PRATT & WHITNEY CANADA
SERVICE BULLETIN

P&WC S.B. No. 13240R2

TURBOPROP ENGINE
COMPRESSOR ROTOR ASSEMBLY - REPLACEMENT OF

PT6A-60A, PT6A-61, PT6A-62

Compressor Rotor Assembly (Rotor) Part Progression
Figure 1 (Sheet 1 of 2)

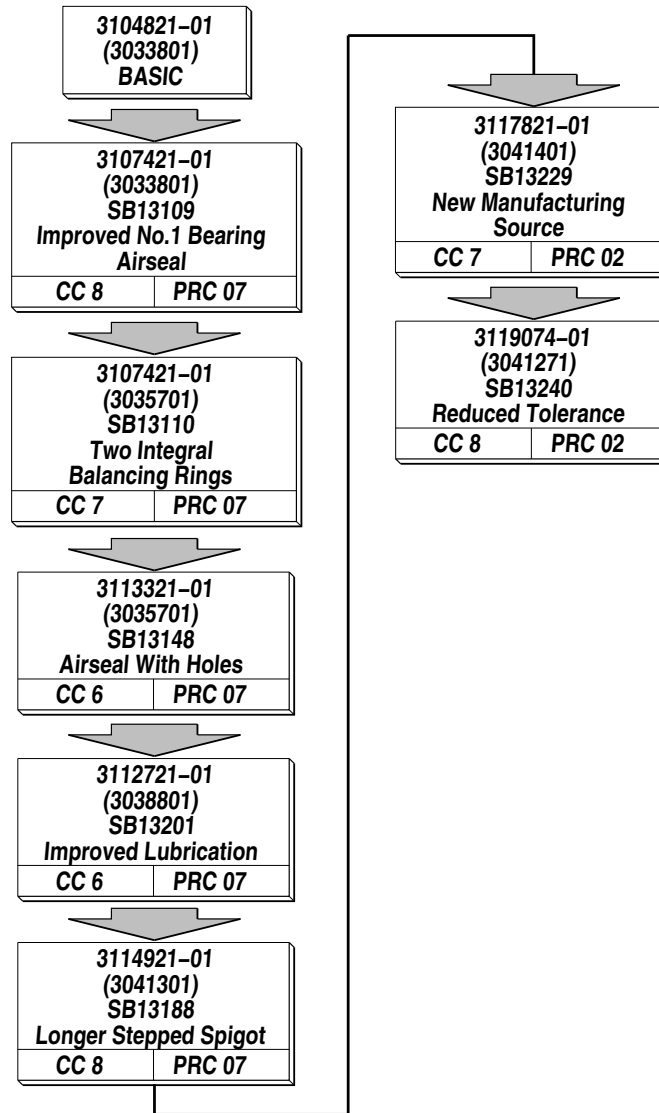
To obtain improved and consistent compressor efficiency, replace the (rear) compressor rotor assembly with a new one which has reduced dimensional tolerances for the rotor blade and the hub and blade tip profiles.

4.	<u>Appendix</u> A. Refer to Figure 1 for the progression of the part. B. Changes to the Fits and Clearances also are in the Appendix
